Subject: USNRC Docket No. 72-1014, TAC L23524
HI-STORM 100 Certificate of Compliance 1014
One-Time Alternative to Codes and Standards - Response to Request for Additional Information

Attachment: RAI Questions and Responses

RESPONSE TO REQUEST FOR ADDITIONAL INFORMATION ASME CODE ALTERNATIVE REQUEST

Finite Element Model (100 psig pressure)

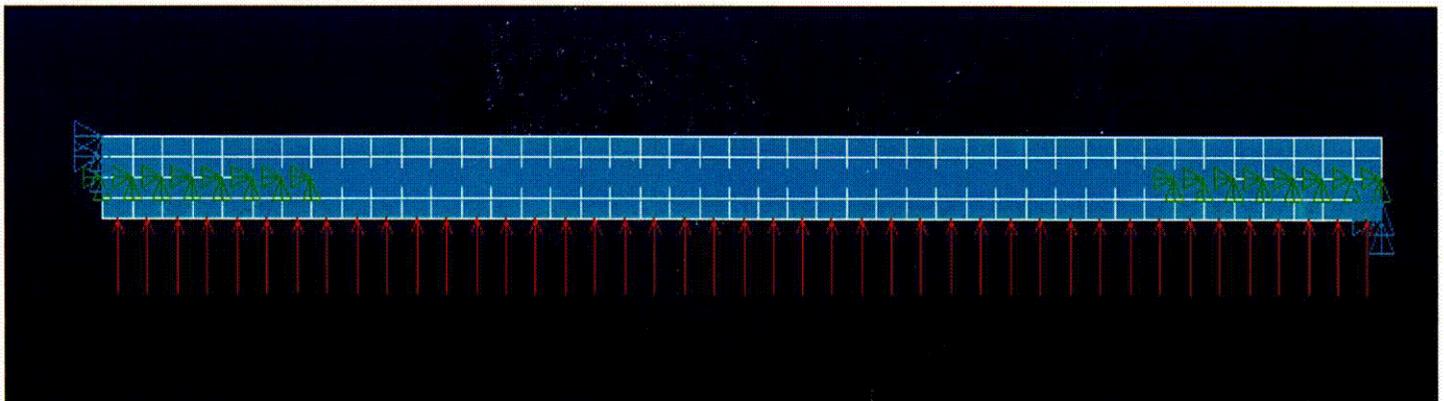
Provide an analysis demonstrating the confinement/structural capability of the MPC closure ring to perform its intended function(s), assuming that the welds for which it is providing a redundant function were to fail (singly or in combination).

This first paragraph of the confinement discussion argues that the closure ring provides a redundant welded closure for the primary confinement boundary, but is not normally pressure retaining. The analysis must demonstrate that the MPC closure ring and welds would maintain confinement and meet Code stress allowables under normal, abnormal and accident conditions. Stating that the MPC closure ring does not normally perform this function is insufficient for demonstrating confinement/structural integrity under postulated conditions. Consideration of the effect(s) of postulated worst-case laminations upon the closure ring attachment welds should be included. For example, an analysis assuming two half thickness plates, simply stacked and otherwise unattached to each other except at the edge welds, may provide the bounding assumption.

Strictly speaking, an internal flaw in the closure ring would produce a localized incremental stress, known as a "peak stress" in the ASME Code. Peak stresses do not have a stress limit, per se. They are significant only in establishing the cyclic fatigue life of a pressure vessel part (Ref. NB-3213.11). However, if the flaw were assumed to be body extensive, such that the flexural capacity of the closure ring is reduced, then the corresponding margin of safety will decrease. To quantify the reduction in the safety margin due to a body extensive flaw, a stress analysis of the closure ring has been performed to determine the effect of an undetected horizontal lamination at the mid-surface of the closure ring. The design pressure of 100 psig is assumed to act underneath the closure ring. The same finite element methodology as is described in HI-STAR FSAR Appendix 3.E was utilized in this analysis. The non-linear finite element model employed to simulate a postulated mid-surface internal flaw that produces a delamination that extends around the entire circumference of the closure ring is summarized below.

To simulate the internal delamination, the mid-surface of the model is defined with a double set of nodes so that the lower two layers and the upper two layers of elements are unconnected. At the inner and outer edges of the closure ring, beyond the flaw, the two sets of nodes are coupled to prevent interpenetration/separation and simulate virgin material. The node sets at the mid-surface within the postulated flaw region are defined to be associated with compression-only contact elements; thus, separation in the middle region of the closure ring is permitted and the lower and upper sets of elements are independent except that normal stress can be transmitted across the interface. The flaw is assumed to extend around the entire 360-degree ring. The radial length of the flaw is varied and the maximum primary stress intensity computed. After iterations on radial flaw length, the maximum flaw radial length (to meet the Level A stress intensity limits) extends from $r = 27.795$ inches to $r = 32.642$ inches; the ratio of flaw span to total span is $4.847/7.188 = 0.674$. The presence of the lamination does not affect the shear capacity of the closure ring, which means that the safety margin of 1.24 reported in the FSAR is unaffected. The figure below shows the model.

The results from the finite element analysis establish that the maximum extent of the all-around flaw permitted without exceeding ASME Code allowable limits is 4.847" out of the total 7.1875" width. In other words, the mid-plane flaw can extend to two-thirds of the total closure ring width around the entire circumference of the closure ring before the computed stress intensity begins to approach the allowable value. This represents a postulated extent of flaw that is wholly inconsistent with industry experience with ASME Section II-certified thin austenitic stainless steel plates
